Product hierarchy no. *				Part no.	SBU	Type / Description	Customer part no.
SBU	PG	PUG	Type				
02	007	001	0000002311	See list below	Connector	2571 Appliance Inlet C6	n/a

UL upgrade from UL 498 to UL 60320-1.

Product Change Notification					2571 Change of marking		
owner	creation date	release date	released by	change order no	rev	page	D10-052-928
zeierjo	31.03.2021	31.03.2021	muehlema	2020483	B	1 of 1

List of part numbers affected

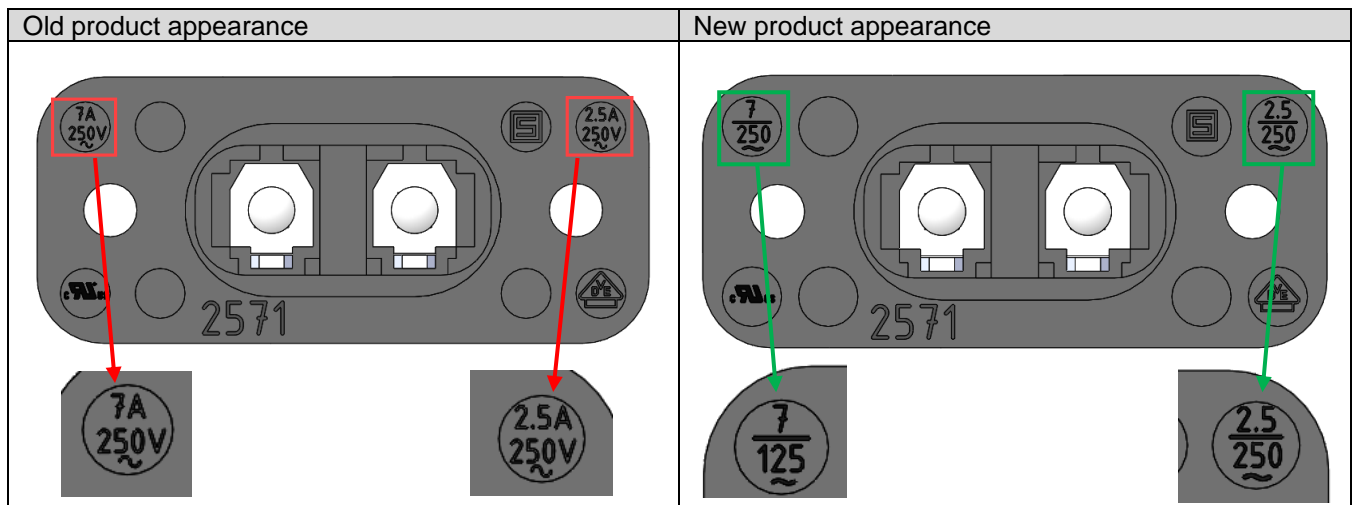
Marking for UL rating 7A/125V~ updated. Marking for IEC rating 2.5A/250V~ updated.
